SB-10045303-2761

Title: Air Horn Broken Off

Applies To: LoneStar model built with a single Air Horn Feature Code 0008WCL between May 11, 2011 through July 12, 2012

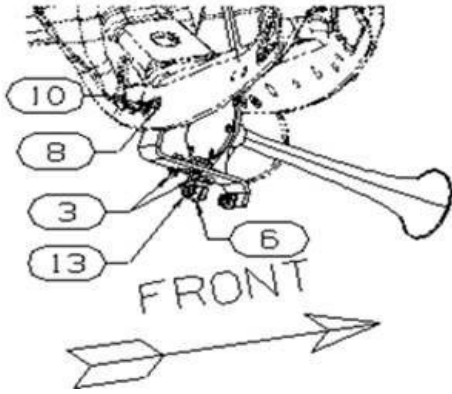
A limited number of LoneStar units have been identified to have been built with the mounting bracket mounted on the wrong side of the crossmember and air horn may be mounted on the lower side of the mounting bracket. This could allow the horn to contact the front axle during normal operation of the vehicle generally resulting in extensive damage to the air horn assembly

1. Inspect mounting bracket to verify that bracket is mounted to the inside of the crossmember as pictured
1. Inspect Air Horn Mounting to be sure horn is mounted on top of the bracket.

Install bracket so that it is mounted to the inside of the crossmember and horn assembly is mounted on top of the bracket
